ARM9TDMI Rev 3 Errata ListARM9TDMI Rev3 Errata List

Document number: ARM9TDMI-PRDC-000577 1.0
Date of Issue: 2nd August 2001
Author: Ian Devereux
Authorised by: Simon Segars

This document describes the known errata in the ARM9TDMI Rev 3 design.

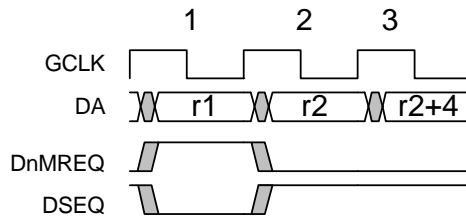
For the first memory transfer of any memory instruction the ARM9TDMI should indicate on its data memory request signals that the transfer is non-sequential. This is indicated by DSEQ being low during this first memory access. However there is a particular situation for a LDC or STC instruction where its first memory transfer can incorrectly be marked as sequential. This case can only be invoked if a LDC or STC instruction, which fails its condition codes, is directly followed by a second LDC or STC instruction which passes its condition codes. For the precise conditions required see below.

During cycle (1) in the diagram above, the DnMREQ is high and DSEQ is low, indicating an IDLE cycle. This corresponds to the IDLE cycle generated by the LDC which fails its condition code check. In cycle (2) the first memory transfer for the second LDC occurs. In cycle DSEQ is incorrectly high, marking the transfer as being sequential.

If a coprocessor is attached with can execute LDC or STC instructions then this errata only applies if the coprocessor can execute an LDC or STC without busy-waiting the processor first. Thus a hardware workaround is to ensure all attached coprocessors insert a busy wait cycle before executing a LDC or STC.

A second work around is to ensure that the code does not contain a sequential instruction pair of LDC or STC instructions where it is possible for the first instruction to fail its condition code check and for the second to pass its condition code check.
